LR-N07-0069
LCR H05-01, Rev. 1
March 30, 2007

Hope Creek Generating Station
Facility Operating License No. NPF-57
NRC Docket No. 50-354

Subject: Response to Request for Additional Information
Request for License Amendment - Extended Power Uprate

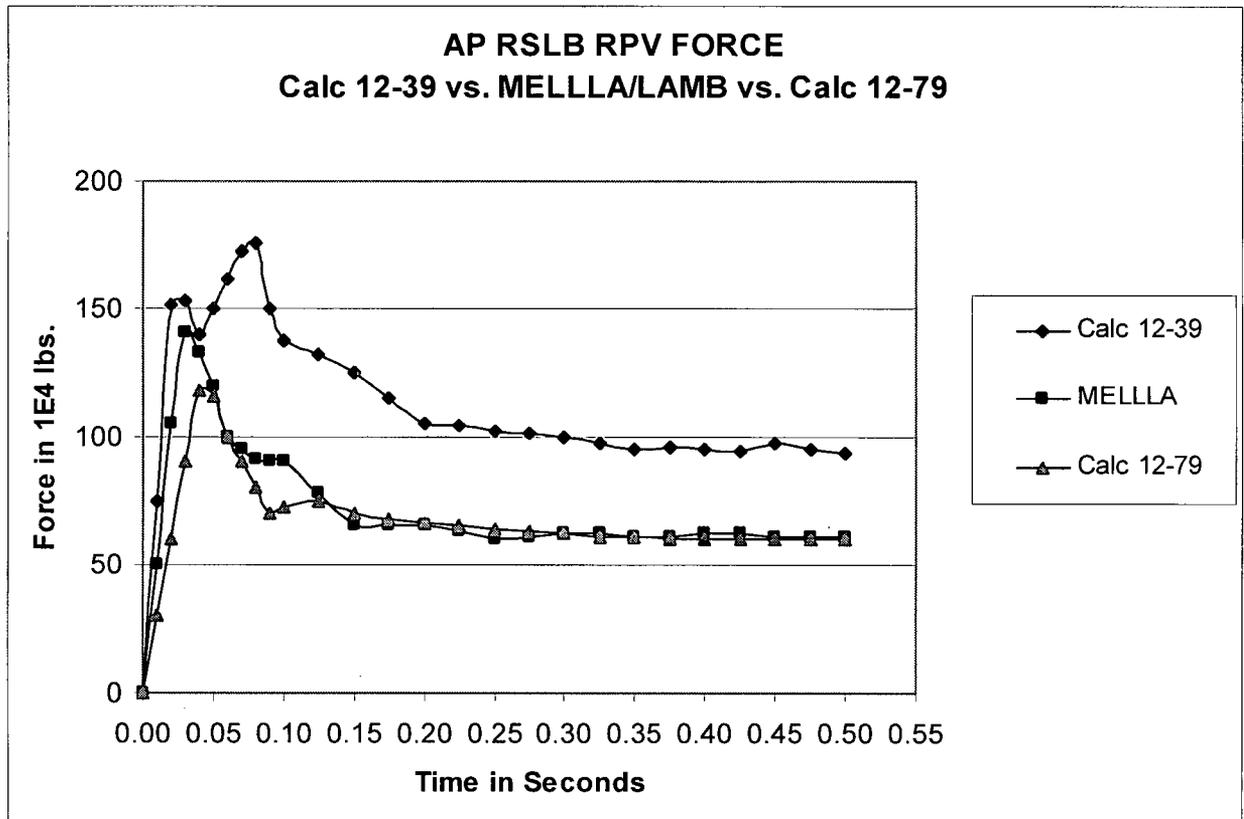
- 13.11 In the Hope Creek PUSAR, Section 4.1.2.3, provide the value of pressure differential calculated for the EPU and the Hope Creek pressure difference limit.

Recirculation Suction Line Break (RSLB) and Feed Water Line Break (FWLB) cases evaluated for ARTS/MELLLA bound the CPPU mass and energy releases for annulus pressurization (AP) and reactor pressure vessel (RPV) loads. The ARTS/MELLLA analyses have been reported to the NRC in LCR H04-01 (ARTS/MELLLA Implementation), with specific details on AP loads included in response to NRC requests-for-information (RAI) by HCGS letter LR-N05-0213 (Reference 13.11-1). Since the ARTS/MELLLA cases bound CPPU, the descriptions and information in LR-N05-0213 remain applicable to CPPU.

The information of LR-N05-0213 contains several plots of pressures and forces from the various analyses along with detailed descriptions on the flow restrictor that was installed during plant construction to reduce mass and energy release into the annulus area. For convenience, a brief summary of HCGS annulus pressurization loads is provided below.

Annulus pressurization loads, both on the reactor pressure vessel (RPV) and the biological shield wall (BSW) are derived by converting time-dependent mass-and-energy release data into loads or forces (in thousands of pounds) on the various components. Original design basis calculations of these loads were performed with the conservative assumption that 50% of the mass and energy

release would discharge directly to the containment, with the other 50% going to the annulus area. These calculations provided the loads on which the designs of both the RPV and shield wall were based.

These original design loads were based on 100% power/100% flow conditions in the RCS. Since original design, it has been determined that the minimum recirculation pump speed point on the MELLLA load line is more limiting (than 100%/100%) for recirculation suction line breaks (RSLB) and feed water line breaks (FWLB). This methodology change (which changes the enthalpy of the water/steam released through the break) has a much greater impact on both CLTP loads (with the MELLLA load line) and CPPU loads than the impact of the increased power level. The results of the methodology change were submitted to the NRC with the MELLLA LCR.

The methodology change notwithstanding, the original design calculations continue to bound both CLTP (with minimum pump speed) and CPPU (with minimum pump speed) conditions because subsequent to the original design, a flow restrictor was installed in annulus penetration that diverts 75% of the mass-and-energy directly to the containment in the event of a line break, with only 25% to the annulus. The 75%/25% flow split is sufficient to compensate for the additional energy provided by the enthalpy change and, the case of CPPU, by the enthalpy change and the higher power level.

The following figure compares RPV loads (in KIPS) from the original design basis calculation with current analyses. The specific plots are described below:

- Calculation 12-39 is the original design basis calculation that assumes the 50%/50% flow split. This calculation remains the plant design basis and the results of this calculation are currently shown in UFSAR Figure 6B-8.
- Calculation 12-79 is the CLTP calculation with 75%/25% flow split and 100%power/100% flow.
- MELLLA is CLTP analysis at with the 75%/25% flow split and the 100% power/minimum pump speed. This analysis bounds CPPU loads

P-0034-0

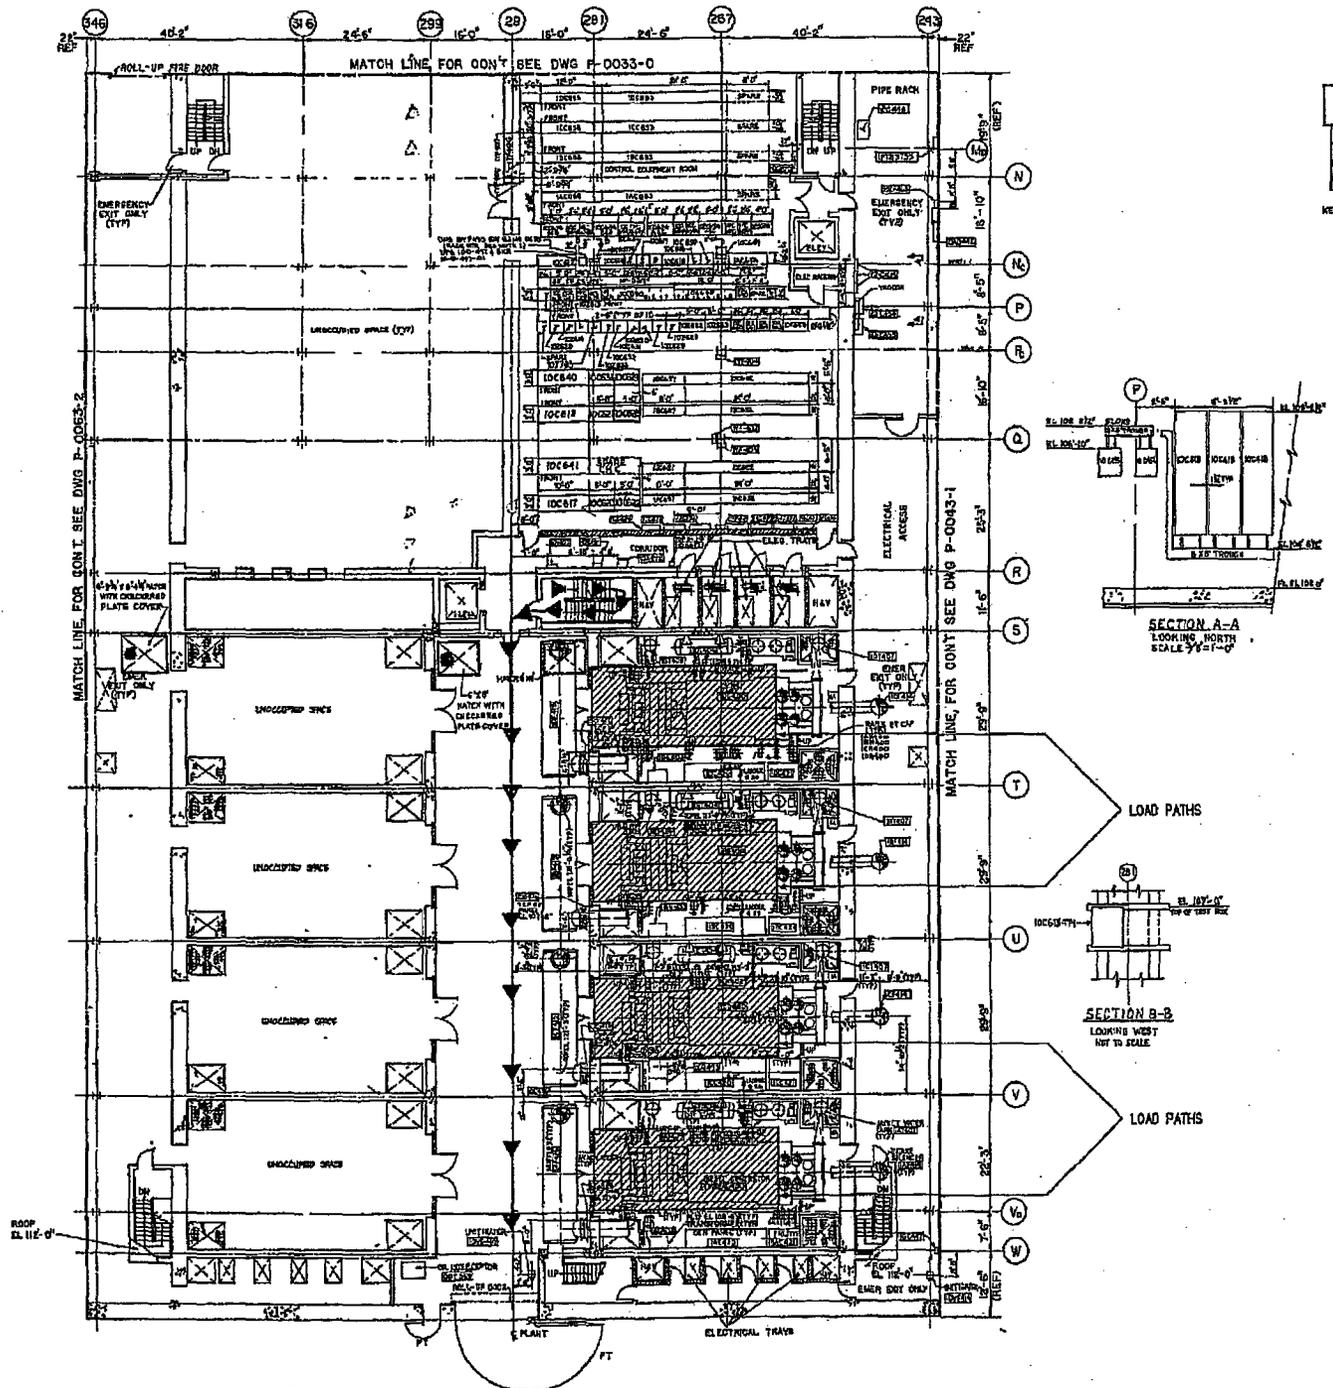
- c) For each of the vital areas listed in Table 8-1, provide a brief description of why the area is classified as a vital area (i.e., what is the vital area function which needs to be performed in the area) and provide plant layout maps indicating the location of each of the vital areas listed in Table 8-1

Plant layout drawings showing the locations of these vital areas are provided with this RAI response. The locations of each of the vital access areas are considered in the analysis in order to establish the atmospheric dispersion factors (χ/Q_s) for the air intake locations. These dispersion factors are used to calculate the bounding submergence and inhaled dose rates listed in PUSAR Table 8-1.
